## HISTORIC AND DESIGN REVIEW COMMISSION

June 15, 2016

**HDRC CASE NO:** 2016-180  
**ADDRESS:** 3220 MISSION RD  
**LEGAL DESCRIPTION:** NCB 7659 BLK LOT 4E  
**ZONING:** MF33 H  
**CITY COUNCIL DIST.:** 3  
**DISTRICT:** Mission Historic District  
**APPLICANT:** EJ Lee  
**OWNER:** Mai Investments, LLC  
**TYPE OF WORK:** Window and door replacement, siding replacement  
**REQUEST:**

**Historic and Design Review Commission  
Design Review Committee  
Report & Recommendation**

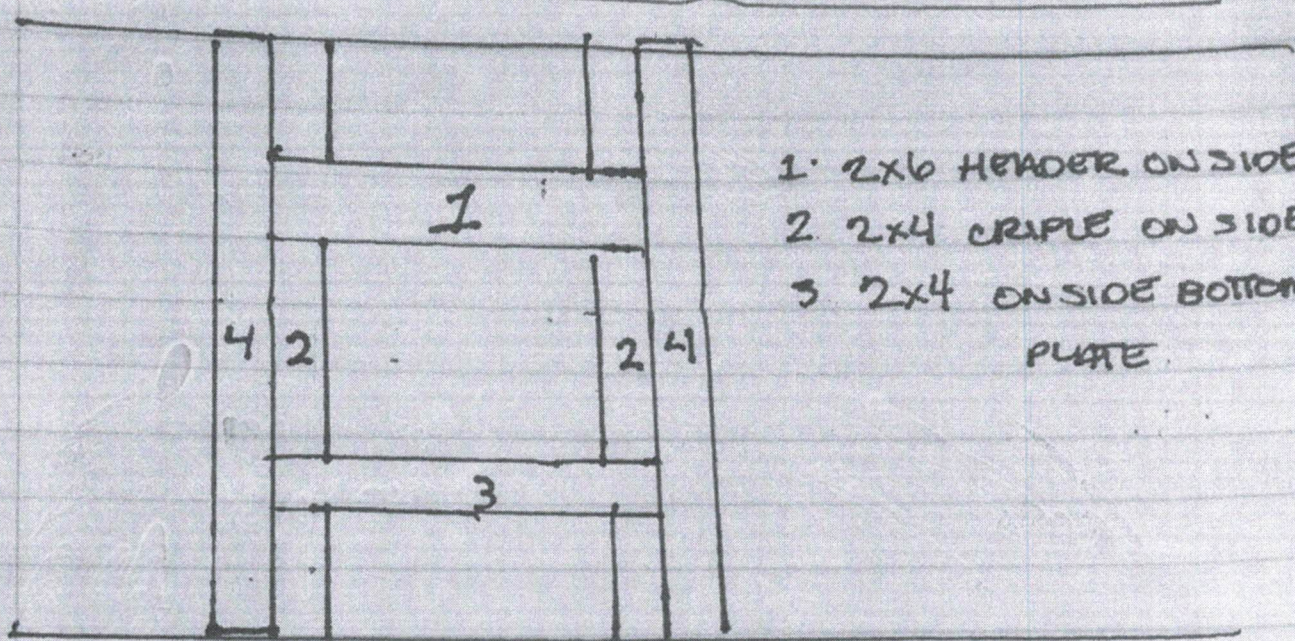
COMMENTS/CONCERNS: DL: Sad to see steel casement  
windows go. There is profile on the trim, which is ok,  
Better to inset. Also remove divide d lights.  
choice I would be to refurbish casement and wood  
windows if financially able. Any plans for the  
Back house? Safety issues? A door without fan  
lite, or a two over two of the same dimension as fan lite.  
Something simple. Craftsman sensibility.  
Hardie at same dimension would be appropriate.

COMMITTEE RECOMMENDATION: APPROVE [ ] DISAPPROVE [ ]
